Change Order # 3 data.
Format (## / ## / ##) = (Previous page total / This Page total / Over all total)
Bid item 2: Ductile 14-16' deep: 0/0/0
Bid item 3: PVC 14-16' deep: 0/0/0
Bid item 4: CIPP: 0/389/389
Bid item 7: MH 10-12' deep: 0/0/0
Bid item 30: Inlet Protection: 0/3/3

TOWN OF LANDIS
SANITARY SEWER SYSTEM REHAB
ROWAN COUNTY, NORTH CAROLINA

DRAWING NO. S-11
SHEET NO. 15

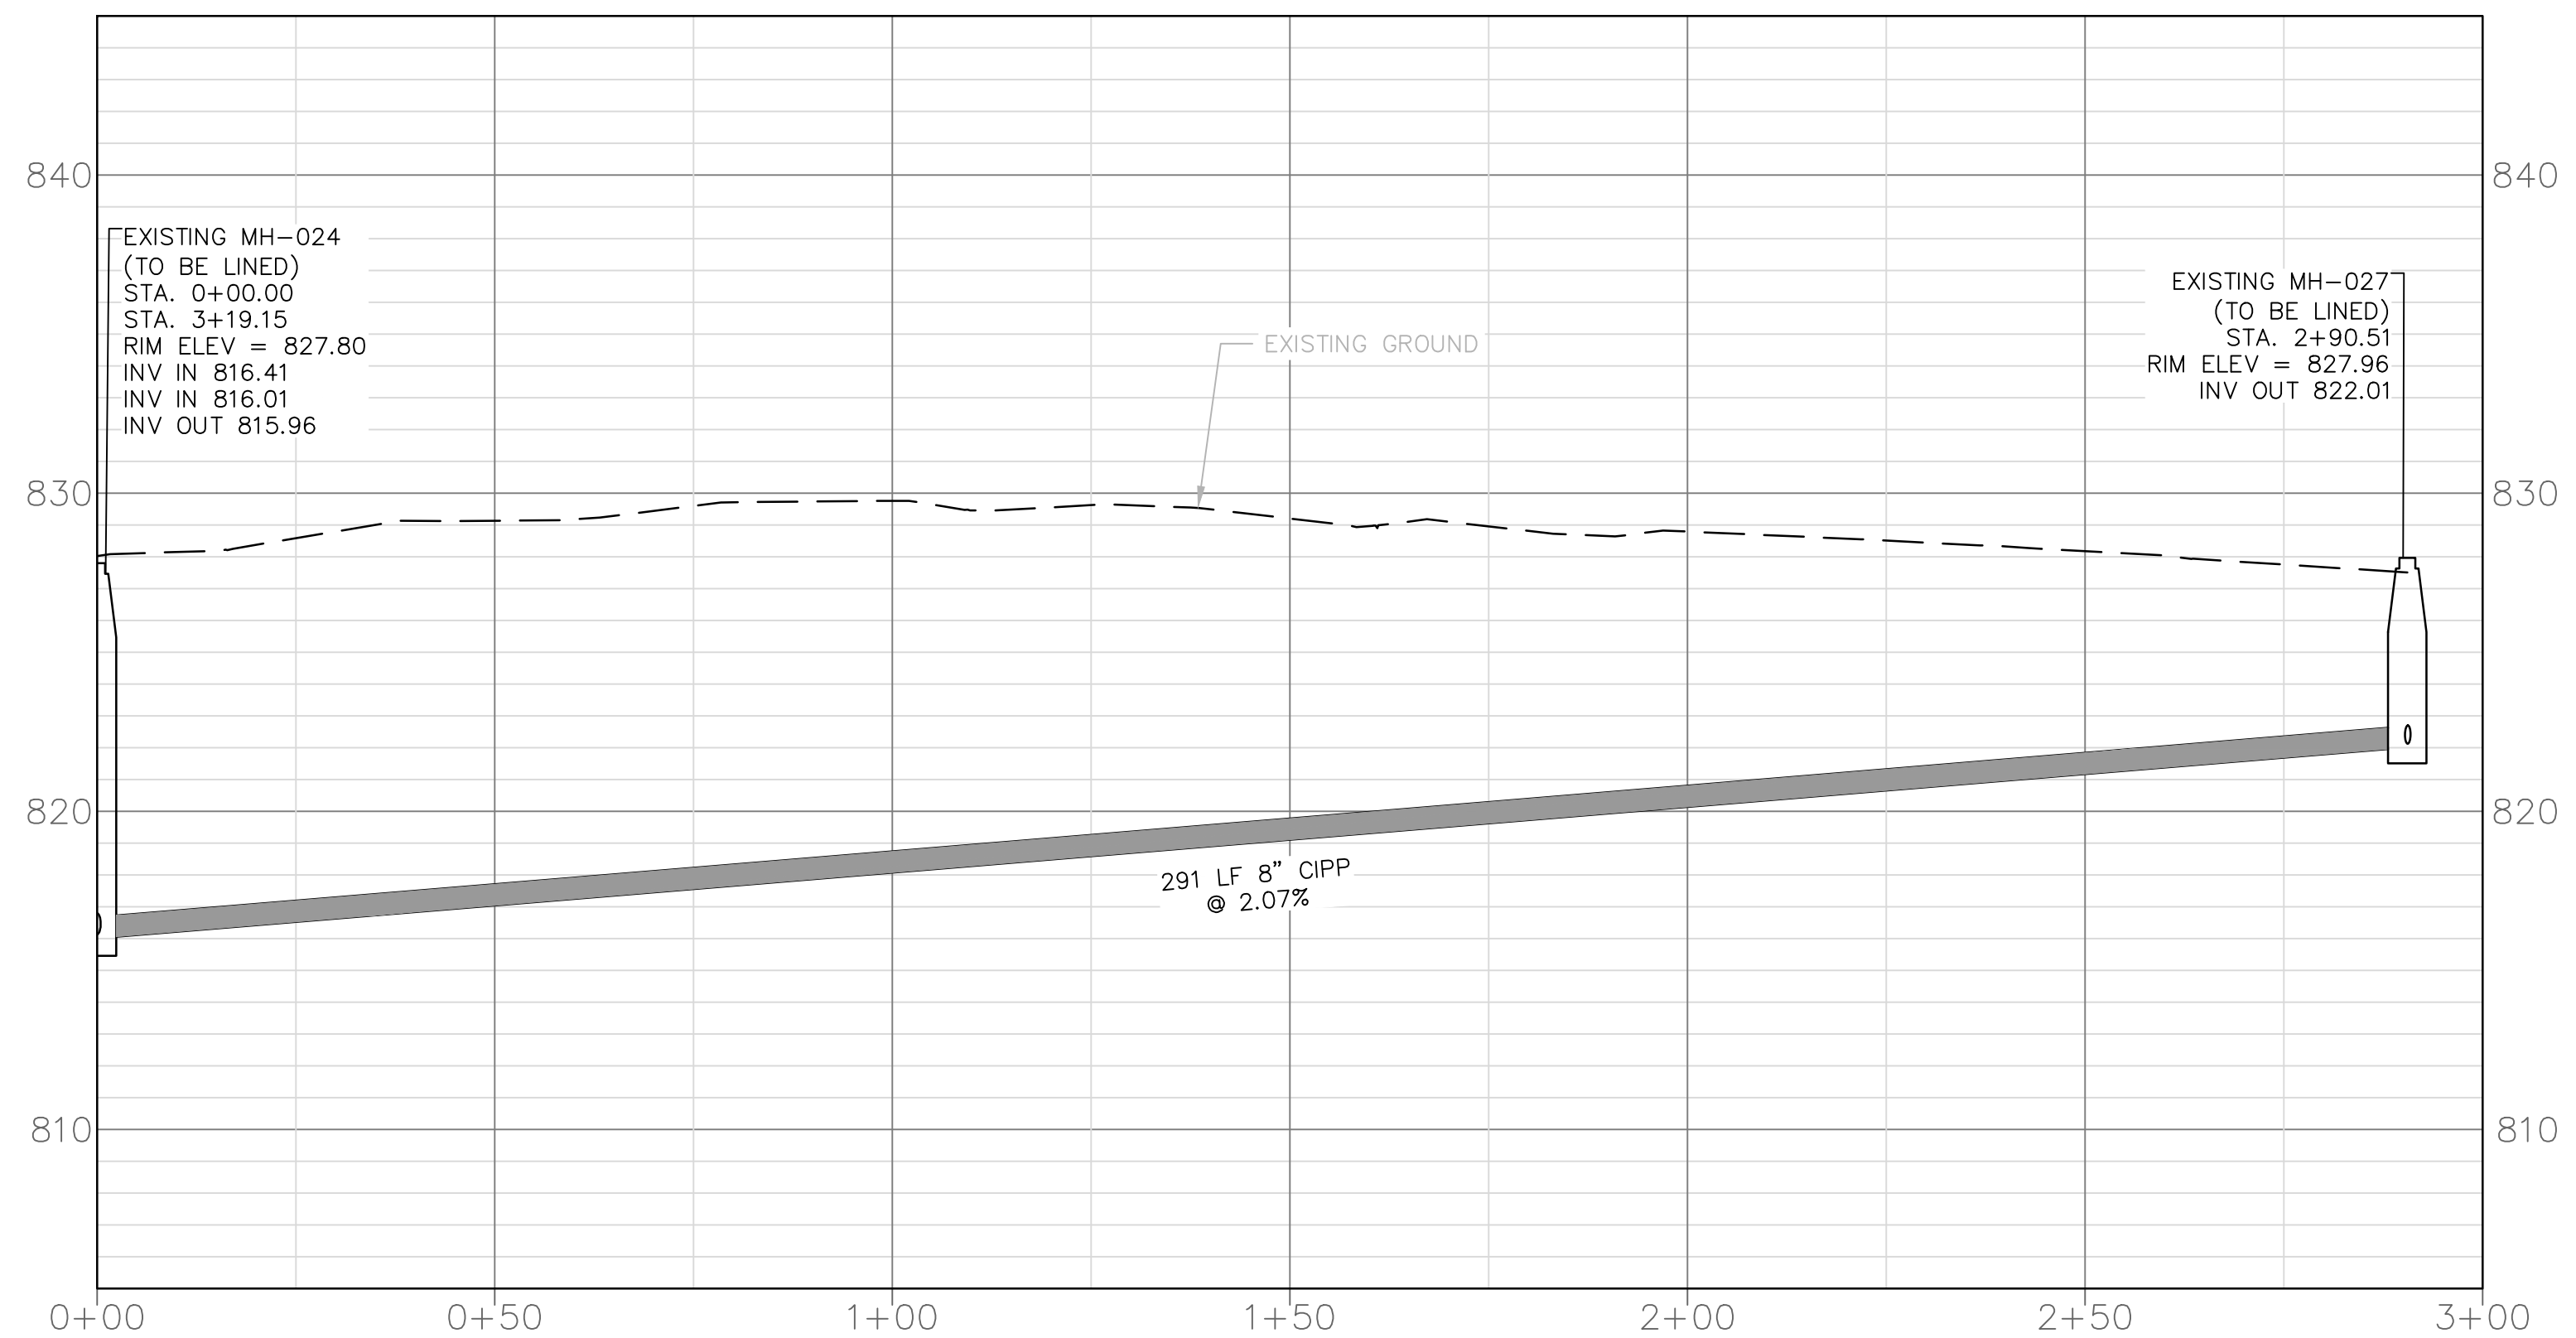
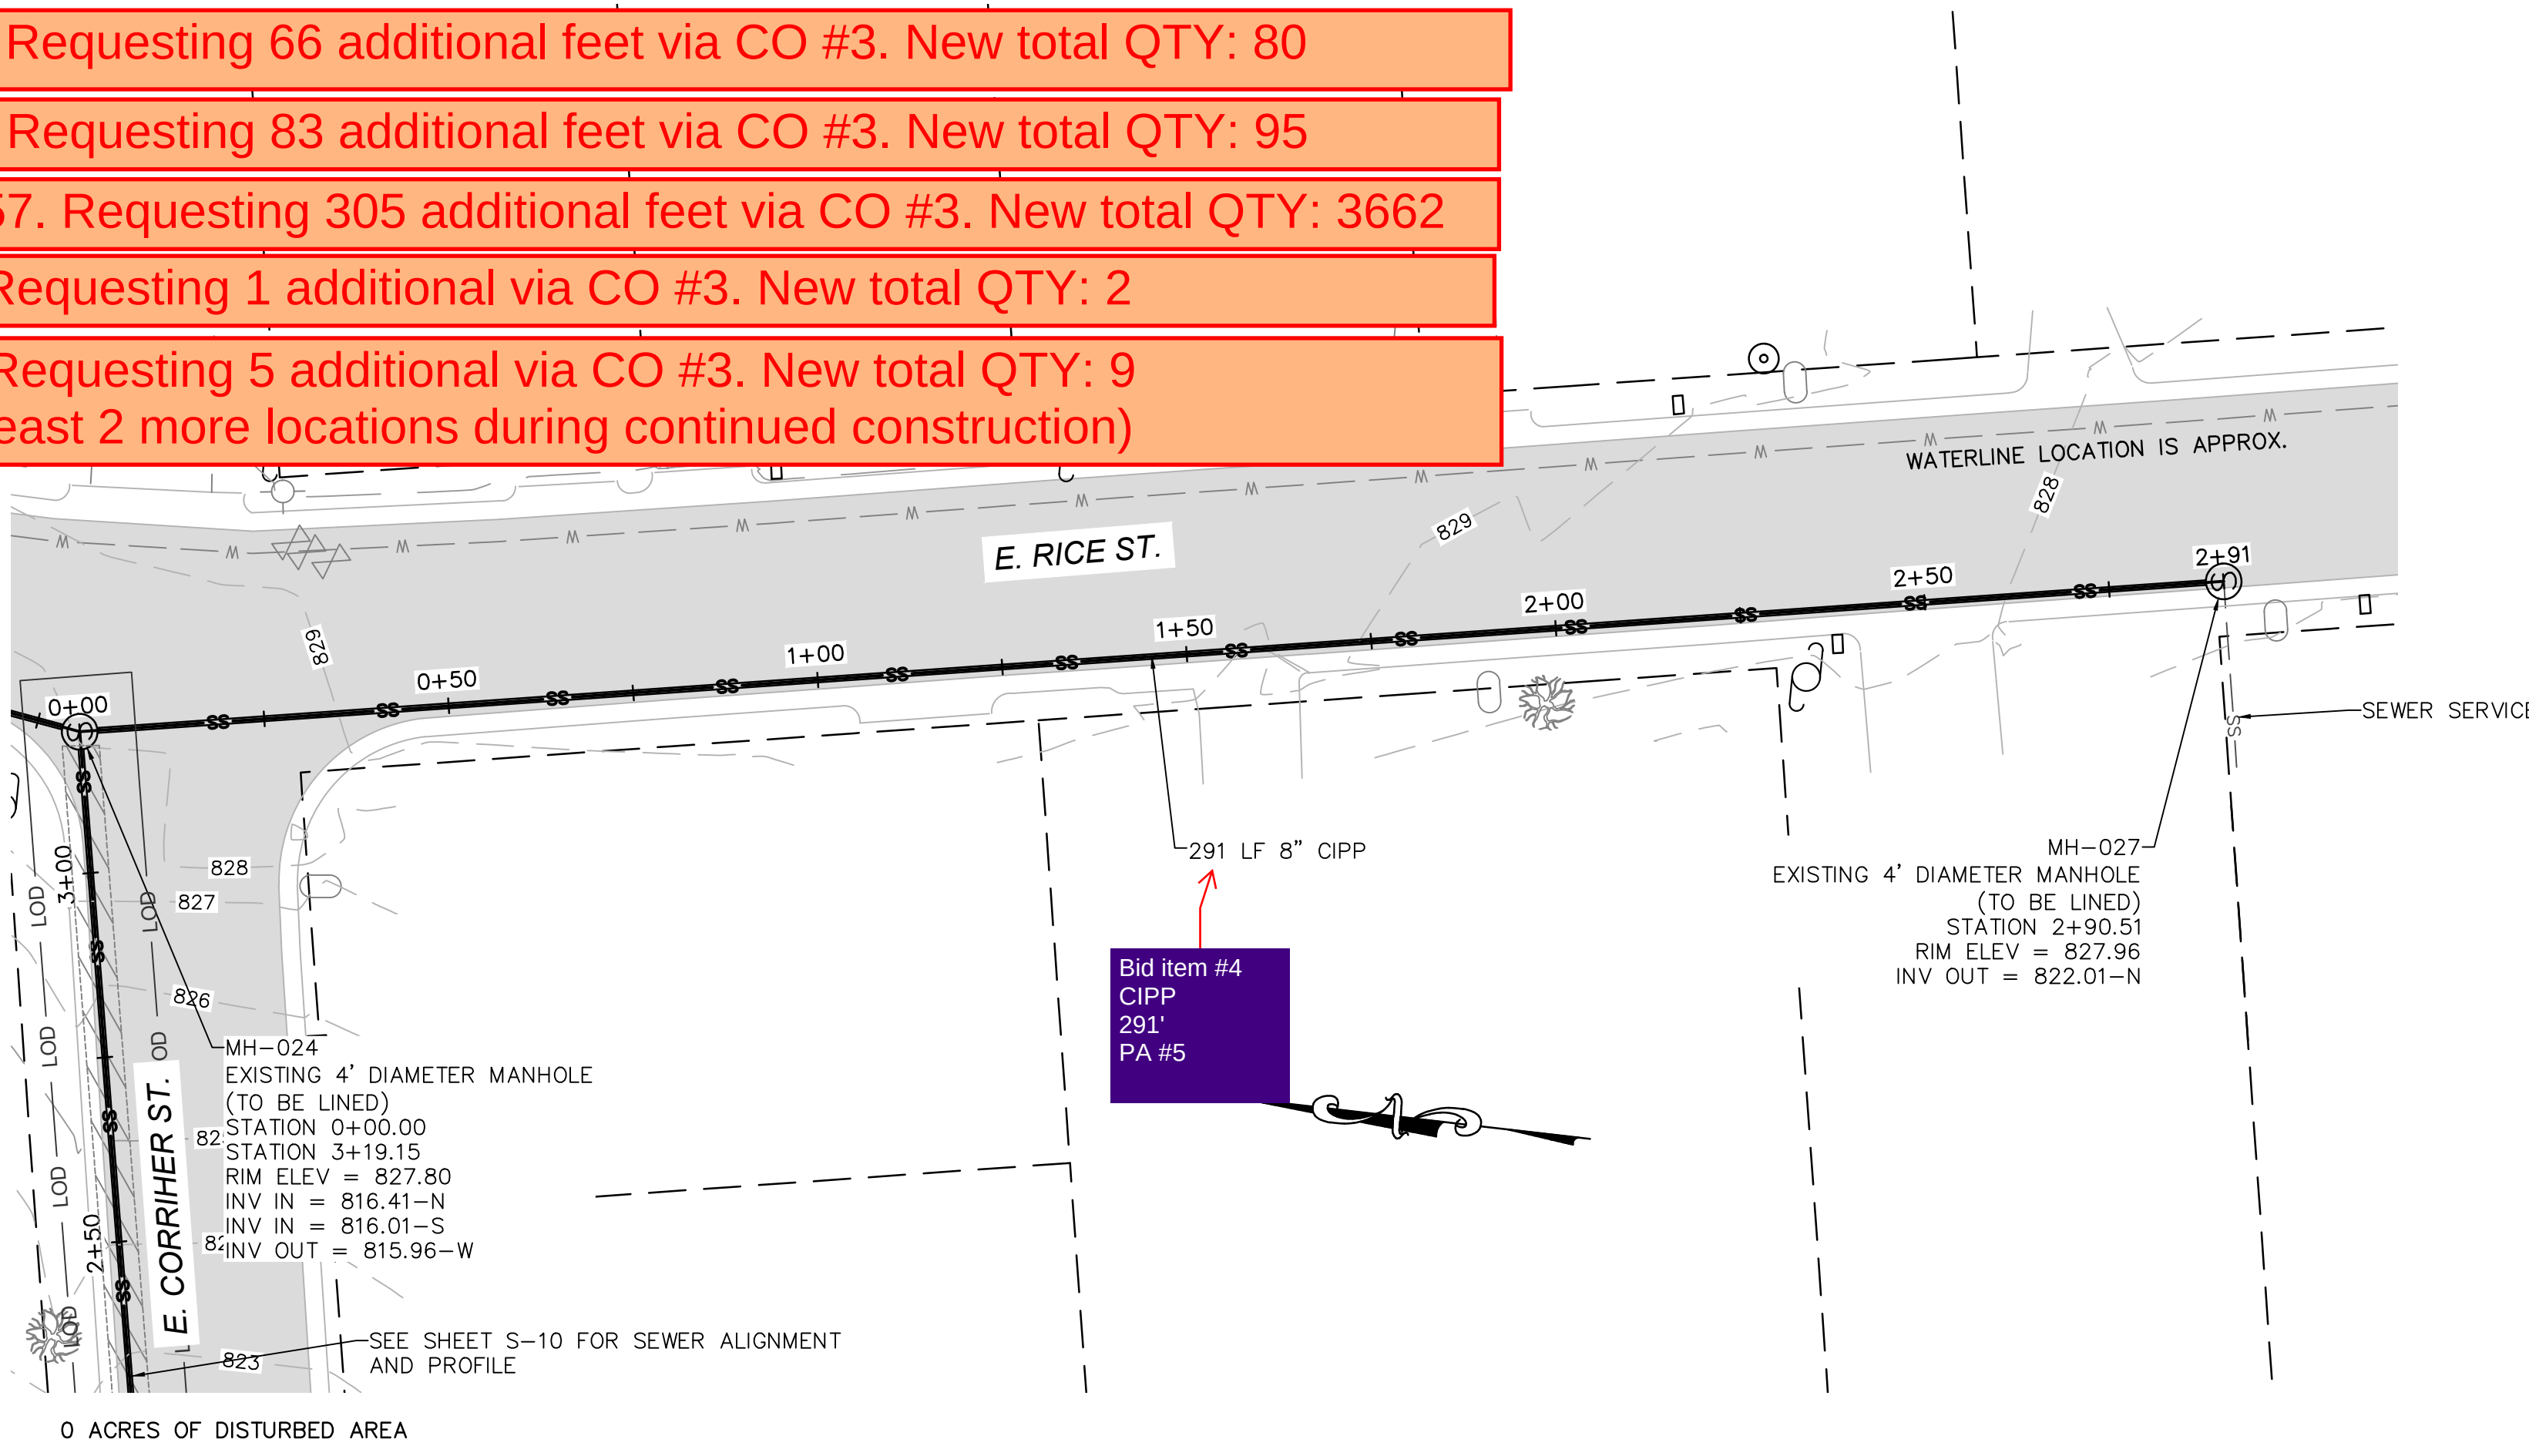
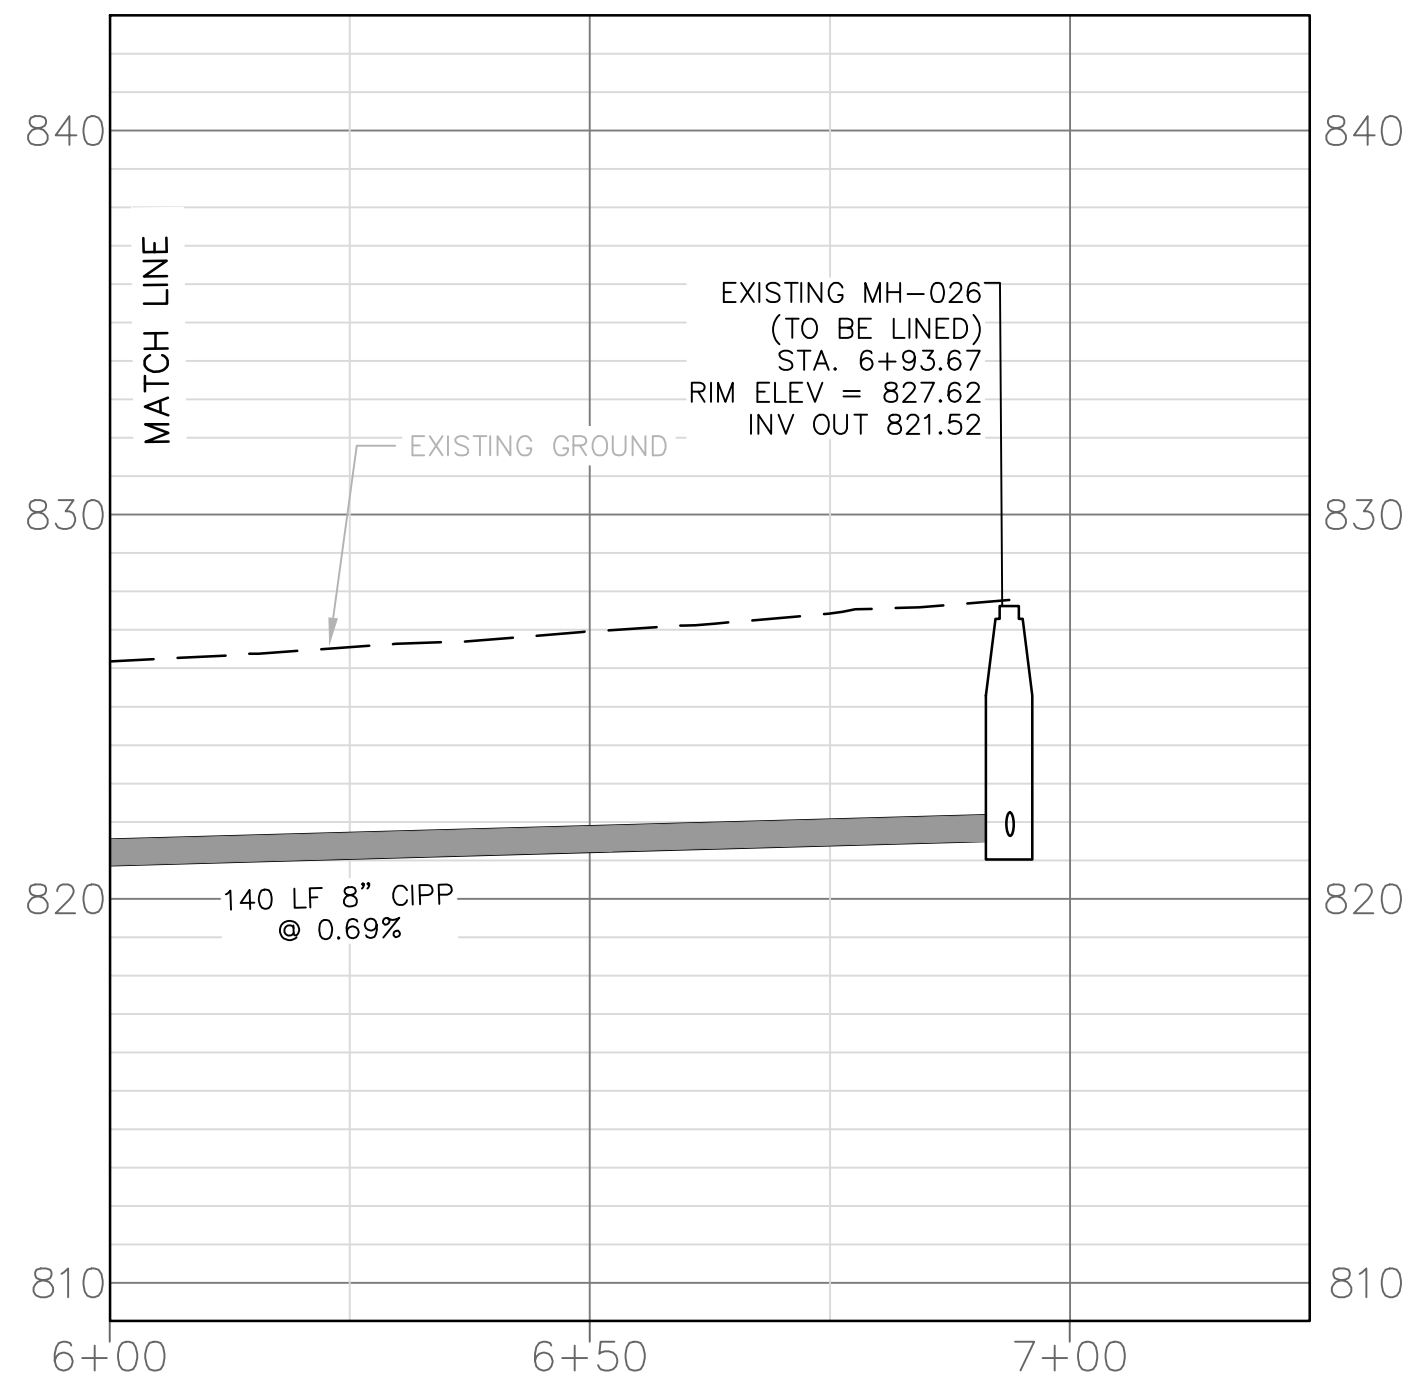
Change Order # 3 data.
Format (## / ## / ##) = (Previous page total / This Page total / Over all total)
Bid item 2: Ductile 14-16' deep: 80/0/80
Bid item 3: PVC 14-16' deep: 95/0/95
Bid item 4: CIPP: 3231/431/3662
Bid item 7: MH 10-12' deep: 2/0/2
Bid item 30: Inlet Protection: 7/0/7

Original Bid QTY:14. Requesting 66 additional feet via CO #3. New total QTY: 80
Original Bid QTY:12. Requesting 83 additional feet via CO #3. New total QTY: 95
Original Bid QTY:3357. Requesting 305 additional feet via CO #3. New total QTY: 3662
Original Bid QTY:1. Requesting 1 additional via CO #3. New total QTY: 2
Original Bid QTY:4. Requesting 5 additional via CO #3. New total QTY: 9
(I expect to have at least 2 more locations during continued construction)
